# UNITED STATES PATENT AND TRADEMARK OFFICE

APPLICATION NO.	FILING DATE	FIRST NAMED INVENTOR	ATTORNEY DOCKET NO.	CONFIRMATION NO.
09/971,763	10/09/2001	Moo-youll Kim	P56598	4212

# Office Action Summary

## DETAILED ACTION

**FIG. 17**

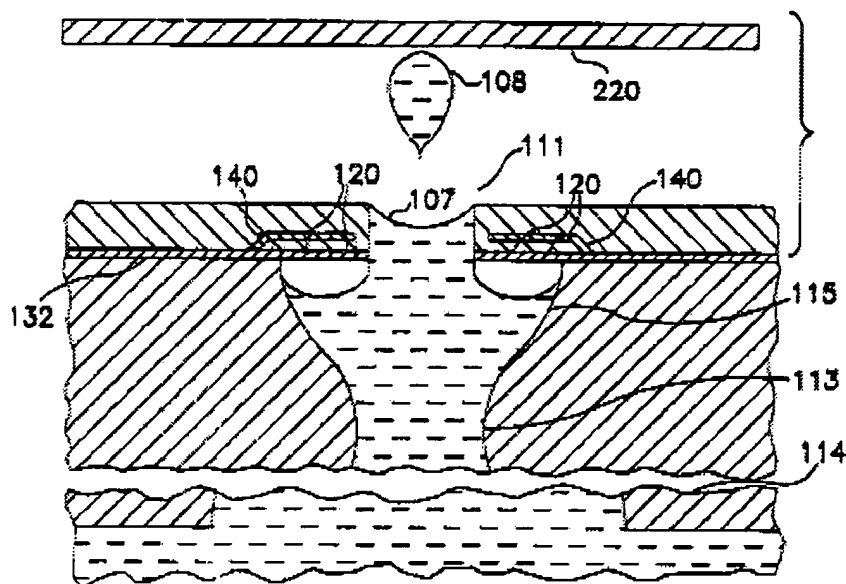
Silverbrook teaches (Fig. 17, above) an ink jet print head comprising a base plate (130), which is perforated by an hour-glass shaped structure having a hemispherical shaped top portion that is filled with ink, a nozzle plate that is mounted on the base plate and is perforated by a plurality of orifices in communication with their respective chambers, a plurality of dough-nut shaped heaters (120) disposed on the underside of the nozzle plate and surrounding each nozzle and a plurality of circular ink inlet passages (113), which supply ink from a reservoir to the hemispherical hour-glass shaped chamber. As can be seen Fig. 18 (which is a reverse structure of Fig. 17), each hemispherical chamber is connected to a funnel shaped chamber (489). Since Fig. 18 is a reverse of Fig. 17, these funnel shaped chambers would be found beneath the hemispherical chambers of Fig. 17.

Silverbrook teaches the claimed invention with the exception of the ink inlet passages each having a plurality of grooves formed at an inner wall, the plurality of

grooves extending through the base plate, the plurality of grooves being formed over an entire portion of said inner wall and the plurality of grooves extending in a direction parallel to a direction through said substrate and the grooves being formed around the entire circumference of the ink passages.
